February 18, 2021

**NOTICE OF ADDENDUM  
ADDENDUM NO. 2  
CONTRACT NO. 8572**

**GARVER PATH & STARKWEATHER DRIVE ASSESSMENT DISTRICT-2021**

**Addendum No. 2, ID 5992-10-41  
Revised sheet S-4  
02/17/2021**

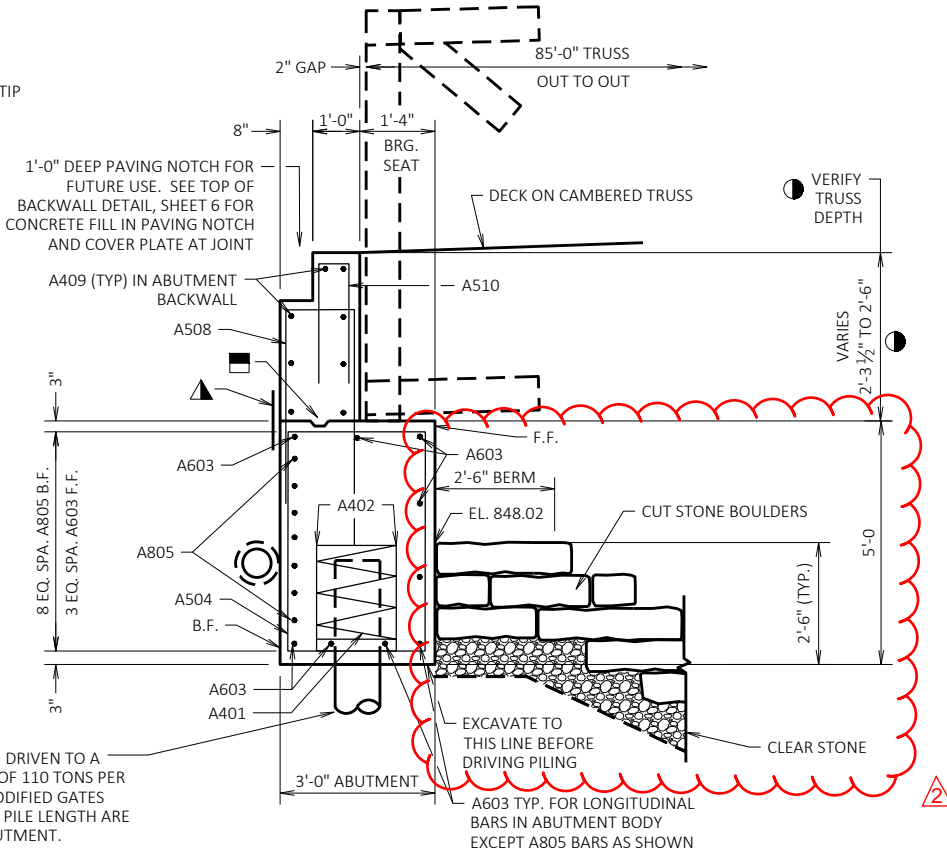
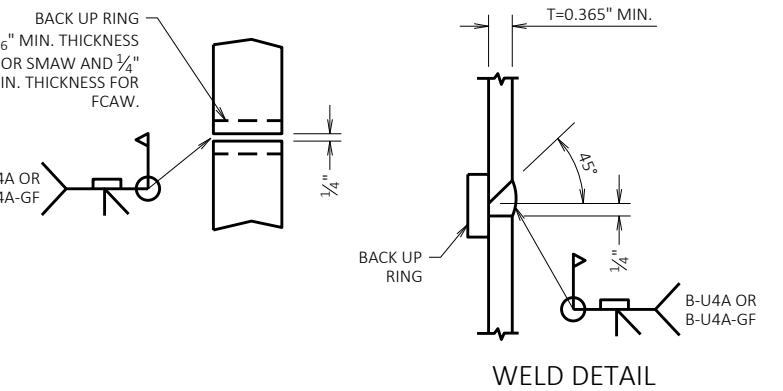
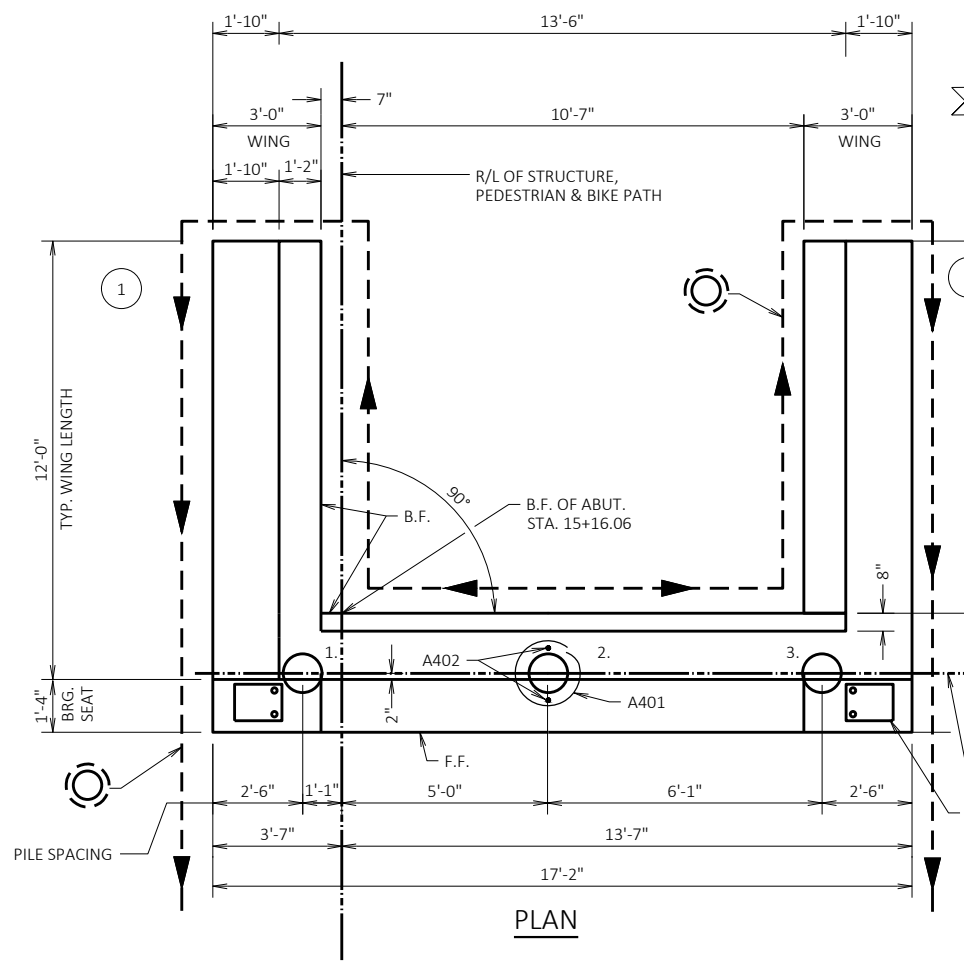
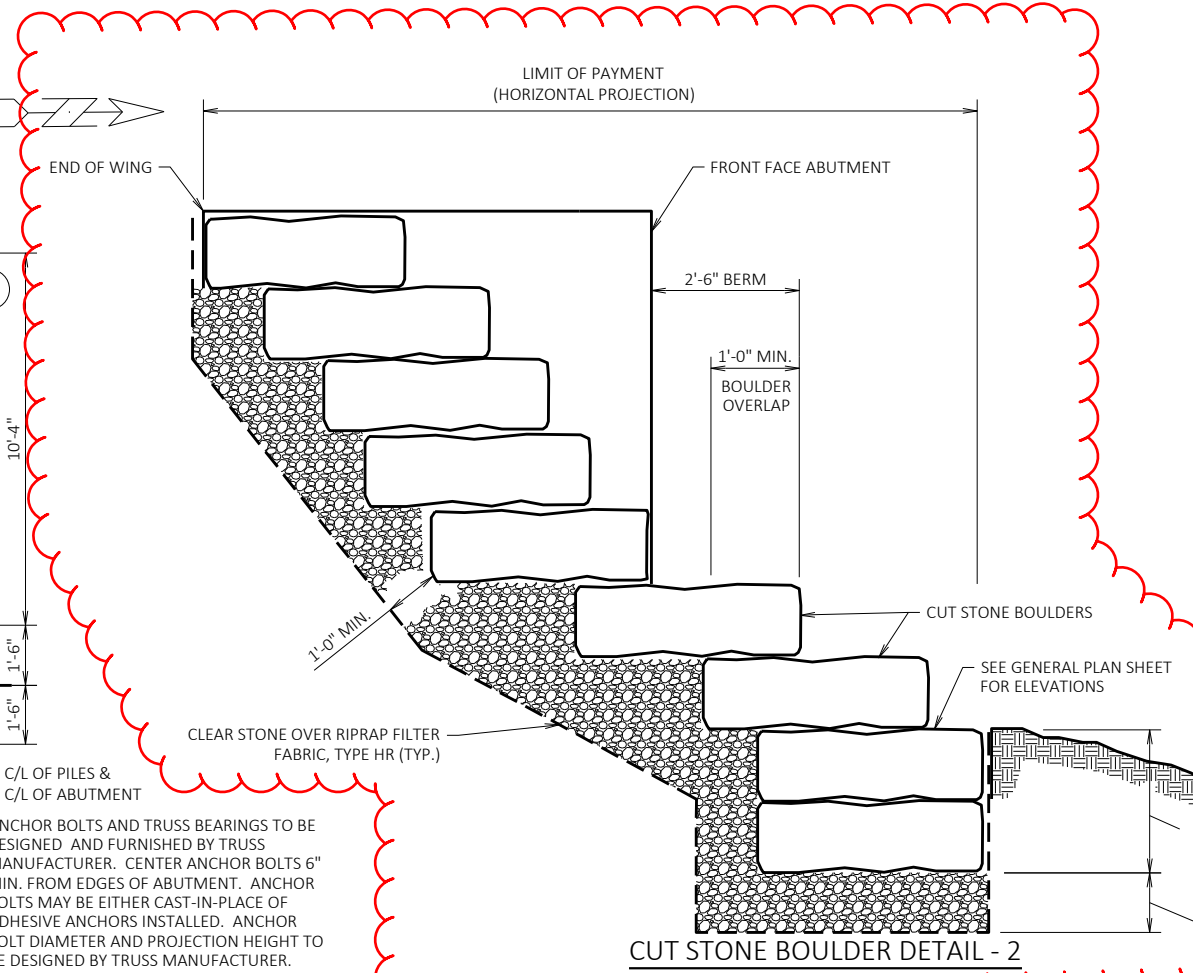
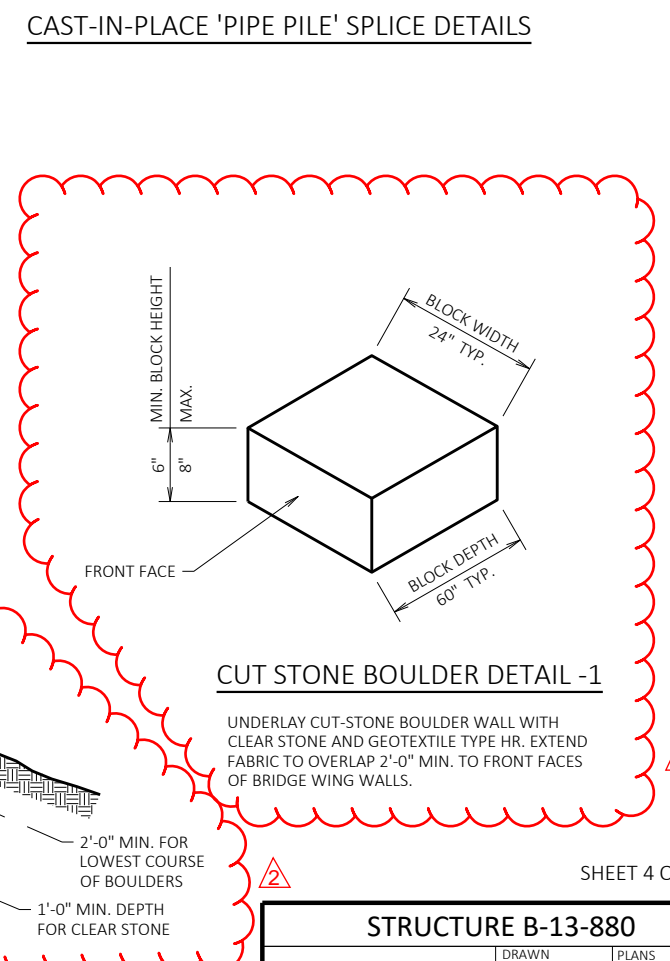
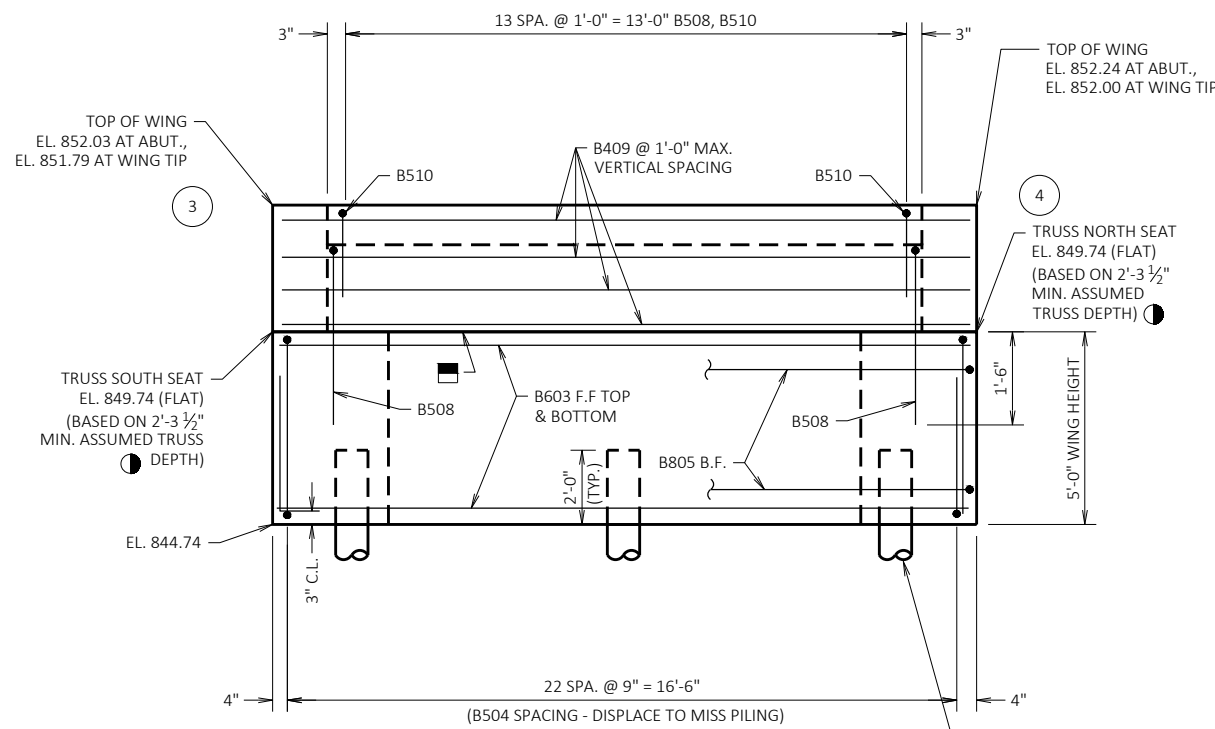
Sheets S-1, S-2, S-4, S-6, S-9, S-10, S-12, S-14 and S-18: Revisions include HSS tubing, lumber treatment, clear stone and revised quantities.
